- Request - Special Use Permit for a used auto sales
- Location - 3952 Jackman Road
- Applicant - Deavonte Williams  
P.O. Box 80309  
Toledo, OH 43608
- Owner - Kit Management LLC  
4478 Monroe Street  
Toledo, OH 43613
- Architect - Architecture By Design  
5622 Mayberry Square S.  
Sylvania, OH 43560

The staff recommends that the Toledo City Plan Commission recommend **approval** of SUP25-0026, a Special Use Permit for used auto sales lot at 3952 Jackman Road, to Toledo City Council for the following **three (3) reasons**:

SPECIAL USE PERMIT  
TOLEDO CITY PLAN COMMISSION  
REF: SUP25-0026  
DATE: September 11, 2025  
TIME: 2:00 P.M.

# SITE PLAN

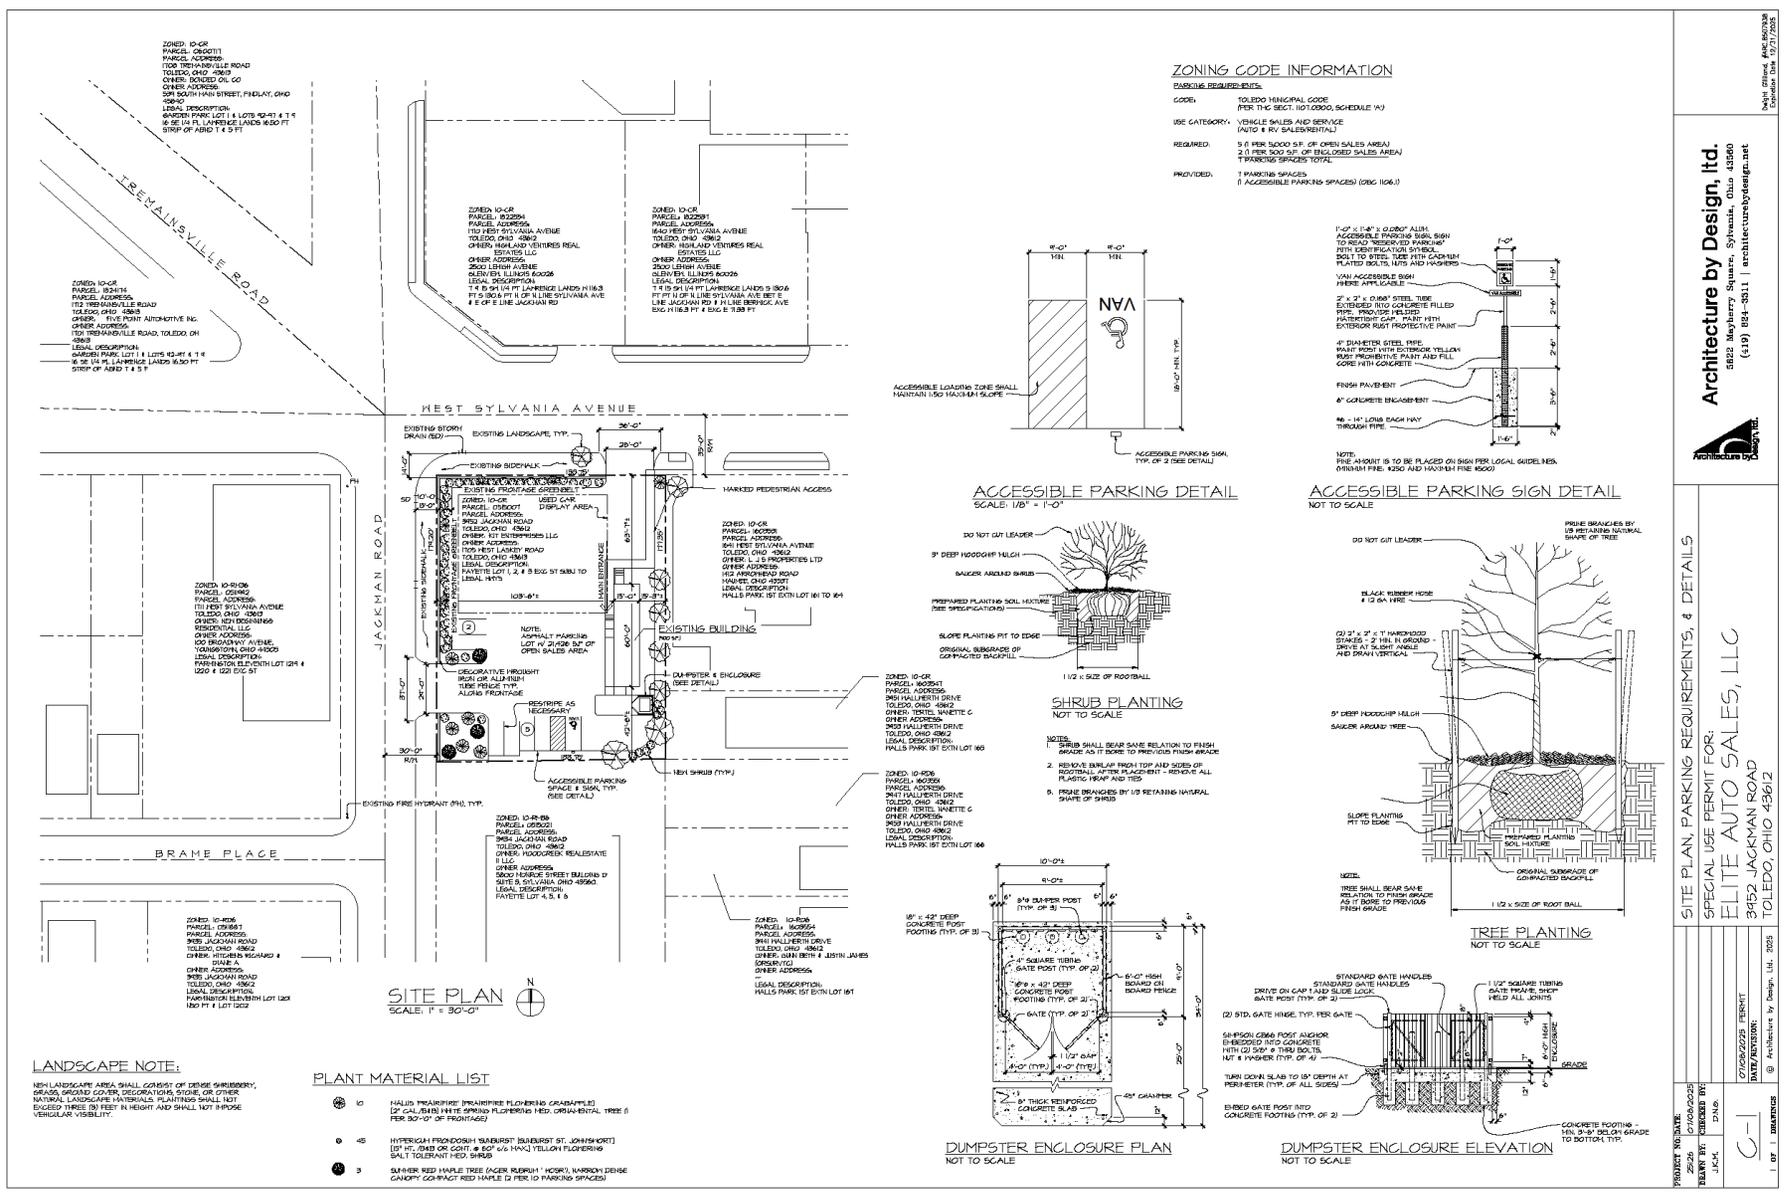
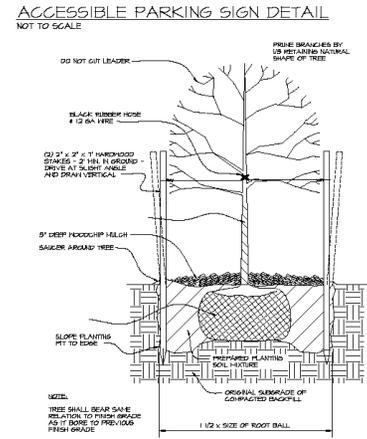
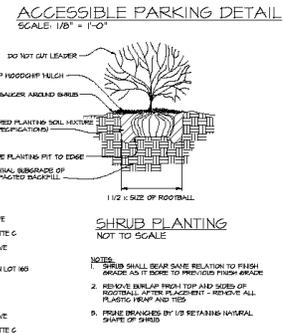
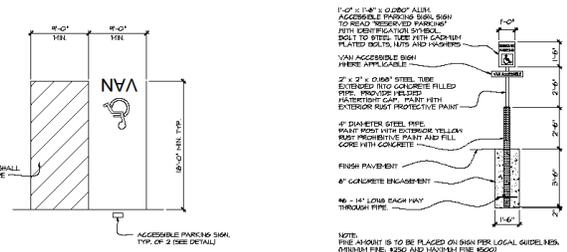
9. Per TMC§1104.0308, all vehicles on display must be parked in striped parking spaces that shall be designated on the approved site plan. Vehicle parking that deviates from the approved site plan shall not be permitted. **Not acceptable as depicted. A revised site plan shall be submitted that delineates the outdoor display area.**

11. Per TMC§1104.0302(B), display areas shall incorporate curbs and other substantial permanent barriers to prevent encroachment of vehicles into the required setback and landscaped areas. **Not acceptable as depicted. A revised site plan shall be submitted that depicts the required curb or barrier.**

15. Per TMC§1107.1202(B), off-street parking facilities, including vehicular drives and maneuvering areas, are prohibited on the subject site within the ten feet (10') landscape buffer along the southern property line, within fifteen feet (15') of Sylvania Avenue street right-of-way, and within twenty-five feet (25') of the Jackman Road right-of-way. **Not acceptable as depicted. The site plan shall be revised so that no parking facilities, including vehicular drives, maneuvering areas and outdoor vehicle display areas are located where noted.**

18. Wheel stops shall be provided whenever a parking lot extends to a property line, sidewalk, planting strip, or building per TMC§1107.1907. Based on the submitted site plan, wheel stops are required for the five (5) customer/employee parking space along the southern property line. **Not acceptable as depicted. Approved wheel stops shall be provided and depicted on a revised site plan for parking spaces as required.**

- a. A fifteen-foot (15') frontage greenbelt is required along Sylvania Avenue with five (5) trees and a solid evergreen hedge per TMC§1108.0202. In addition, a twenty-five-foot (25') frontage greenbelt is required along Jackman Road with six (6) trees and a solid evergreen hedge. **Not acceptable as depicted. A revised landscape plan shall be submitted that depicts the required frontage greenbelt width and required trees.** The species and/or cultivar of the trees to be planted in the frontage greenbelt shall not be "messy" in nature so that fruit, seeds, etc. do not drop on the adjacent public sidewalk, and the proposed shrubs shall be evergreen.

- b. A Type "A" landscape buffer is required along the southern property line where the abutting property is zoned RM36 per TMC§1108.0203. A ten-foot (10') wide buffer with six (6) trees, twenty (20) shrubs and a privacy fence is required. One (1) new tree, one (1) existing tree and three (3) shrubs are depicted on the site plan. The abutting property to the south has a privacy fence for a portion of the property line. **Not acceptable as depicted. A revised landscape plan shall be submitted that depicts the required six (6) trees and twenty (20) shrubs and a privacy fence, where not currently provided.**

- d. Dumpster screening is required per TMC§1108.0203(G). **Acceptable as depicted.**
  - e. Parking lot perimeter landscaping is required per TMC§1108.0204(B)(9) and must be installed along any parking lot area adjacent to a street, place, or driveway, or is visible from an immediately adjacent property. **Not acceptable as depicted. Parking lot perimeter landscaping shall meet this requirement by complying with Condition 19a and 19b.**

- f. Interior landscaping for parking lots is required per TMC§1108.0204 at a rate of twenty (20) square feet per parking space. In addition, two (2) canopy trees and six (6) shrubs for each ten (10) parking spaces are required. The outdoor vehicle display area needs to be depicted on the site plan to determine the required interior parking lot landscaping. **Not acceptable as depicted. A revised landscape plan shall be submitted that depicts the required interior landscaping per TMC§1108.0204 based on a revised site plan that delineates the outdoor vehicle display area.**

- g. Interior site landscaping is required per TMC§1108.0205. One (1) 2-inch caliper tree, landscaping at major building entrances, and foundation plantings are required. One (1) tree is depicted on the site plan. **Not acceptable as depicted. A revised landscape plan shall be submitted that depicts the required foundations plantings and landscaping at major building entrances.**

- j. The location, number, height, diameter and species of any materials to be planted and maintained, as well as the location and number of any existing trees to be retained. **Not acceptable as depicted. The species and size of trees to be preserved shall be provided.**

- m. The location, height and materials for any fencing to be installed and maintained. **Not acceptable as depicted. A revised site plan shall be submitted depicting the location of all required fencing and fence details. This shall include a note that a new privacy fence shall be installed along the southern property line should the existing privacy fence ever be removed from the abutting property.**

- n. The location and direction of any proposed lighting. All site lighting shall be fully directed downward, recessed, or adequately shielded to direct light away from adjacent properties, rights of way, or the sky above the fixtures per TMC§1107.1908. The existing site lighting is not depicted on the site plan. **Not acceptable as depicted. A revised site plan shall be submitted depicting the site lighting if it will continue to be used. All missing fixtures shall be replaced. If the lighting is not operable and/or is not intended to be used or fixtures not replaced, the lighting shall be removed from the site.**
